Swan soundbar

Speaker cable drawings for control run + Pre-MP + MP(~15K)

ALT Co., Ltd.

Issued Date 2021.08.24

SPEC_4AI20-CMXX04 – Left channel speaker cable

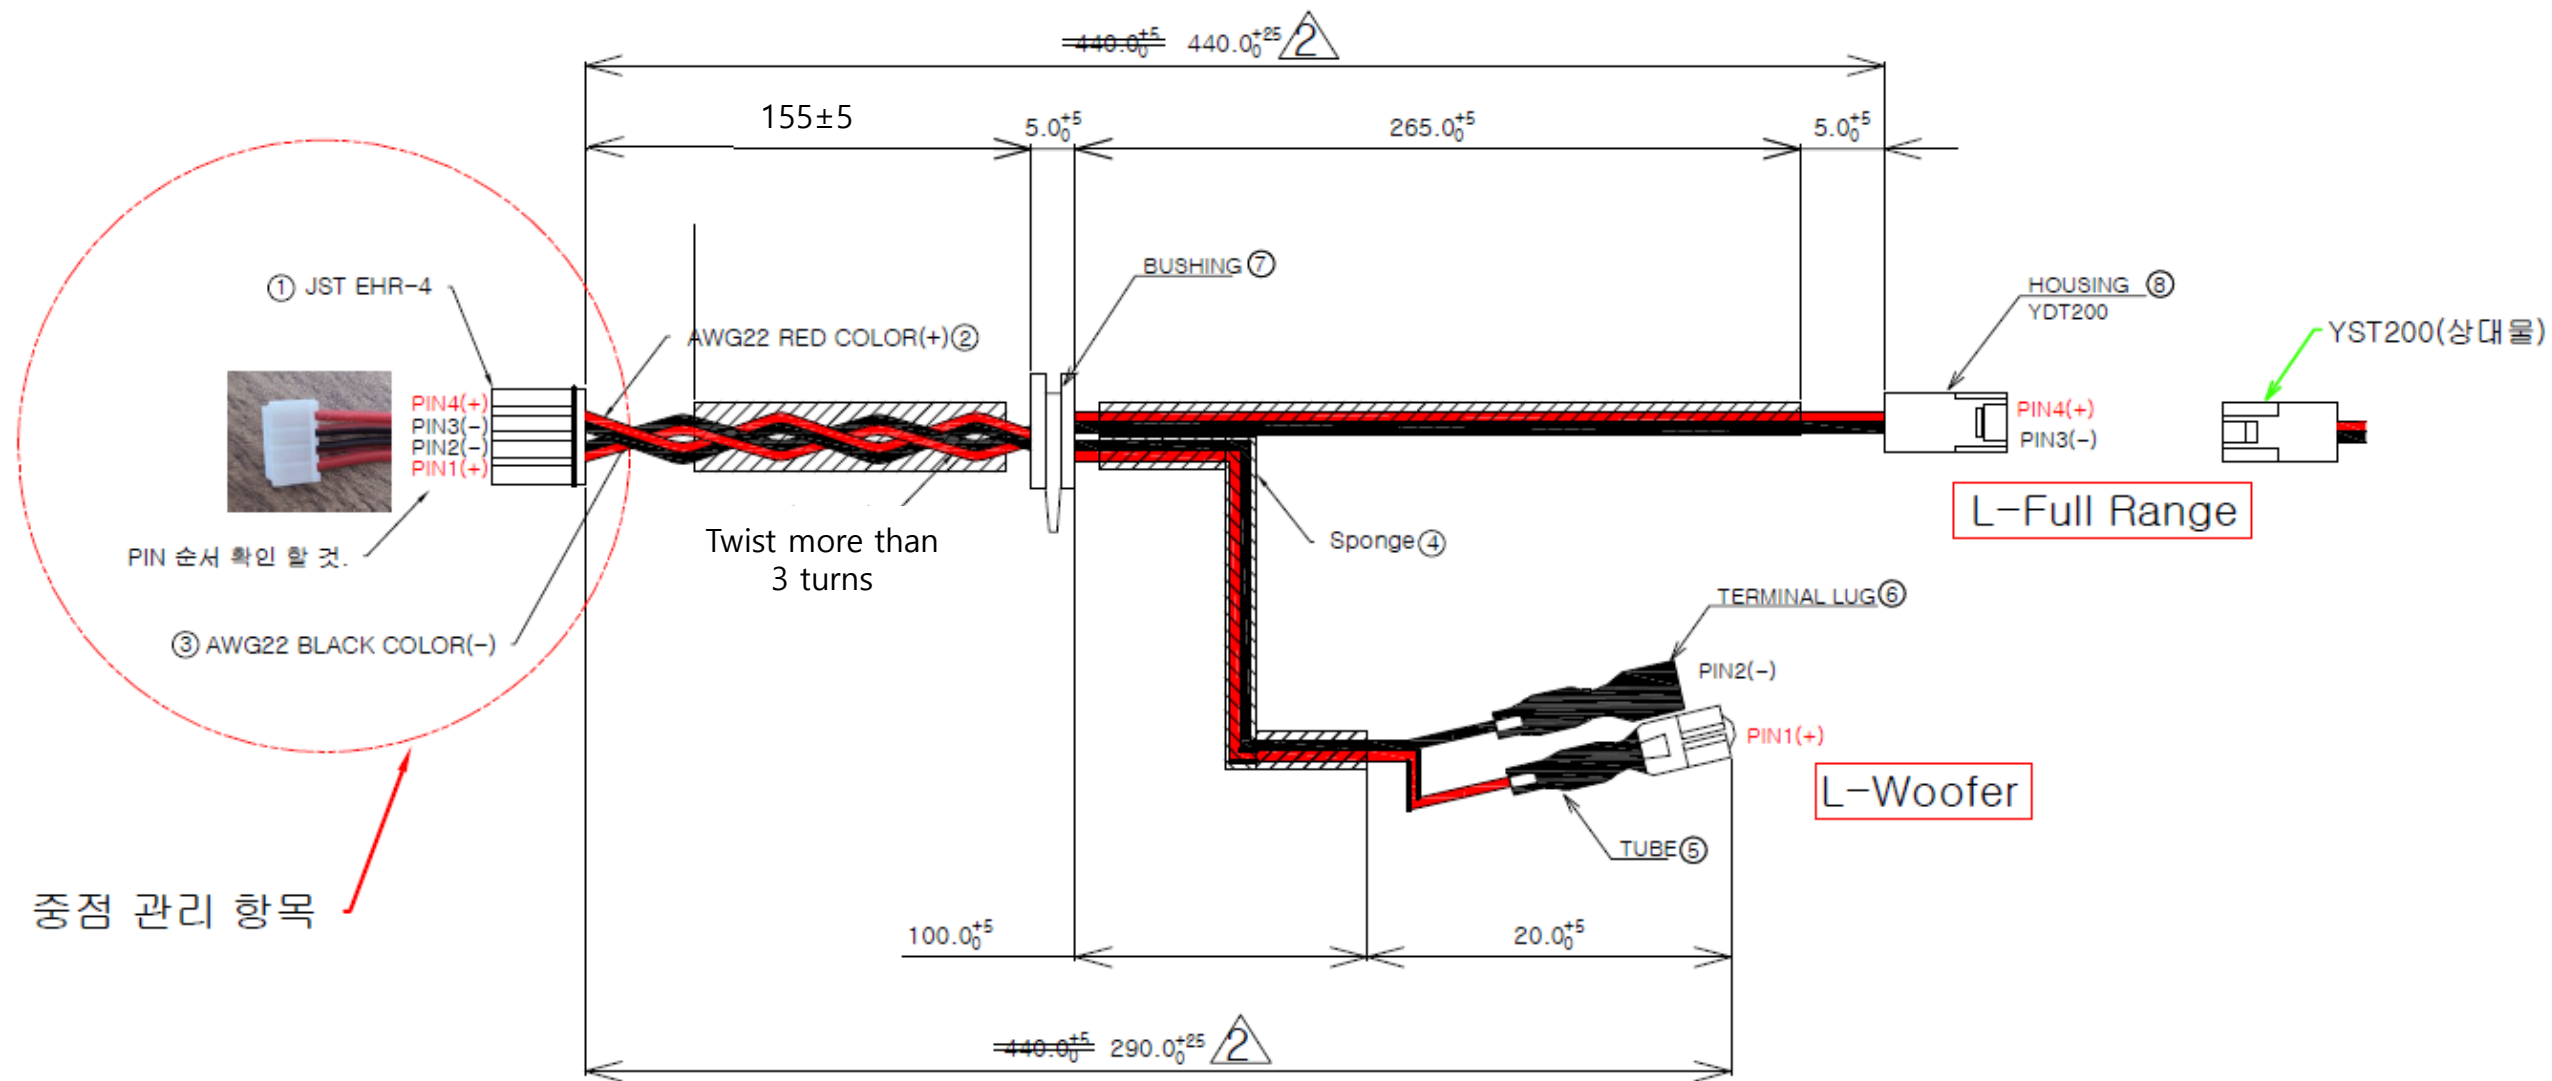
- Due to cable twist **rework by hand**, twist length may vary.
- Rework cable will be supplied up to 15K production.
 - After 15K, will be supplied the drawing dimensions by **machine work**.
- Request to factory
 - Skip the IQC on cable twist spec
 - If the cable twist less than 3, please twist more when final assembly
 - Please refer to the guide for next page

SPEC_4AI20-CMXX04 – Left channel speaker cable

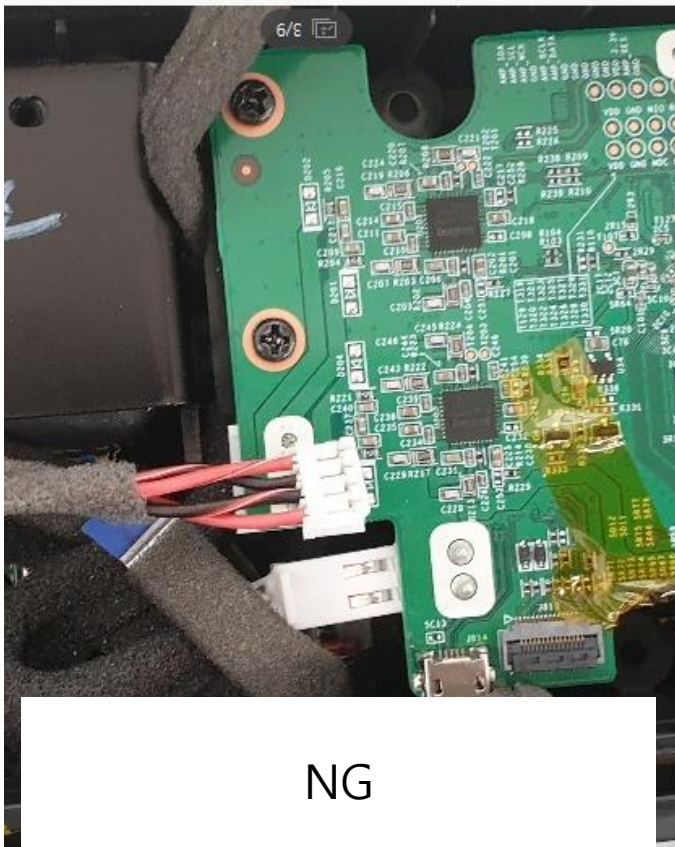
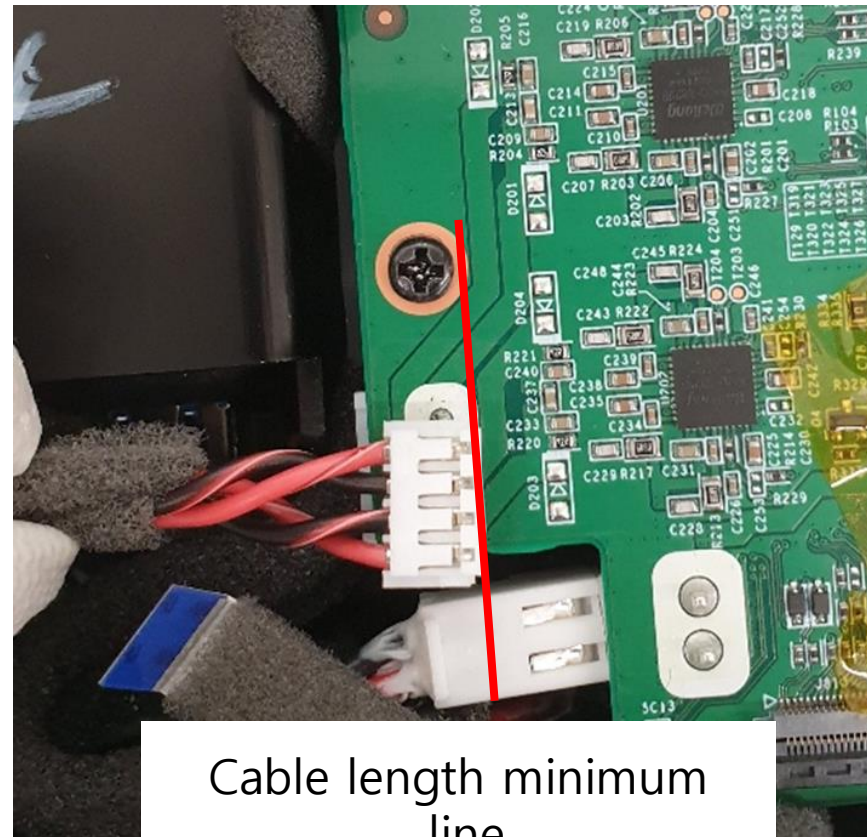
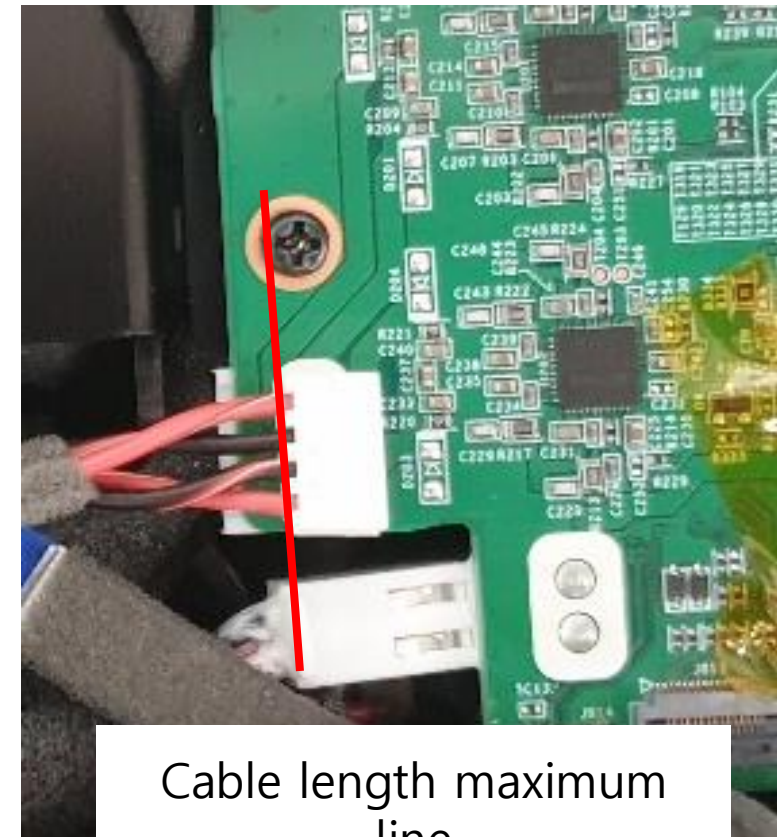
- The speaker connector should be placed on the silk area
 - if the speaker connector is not placed on the silk area, please twist the cable
 - See below min / max cable length example
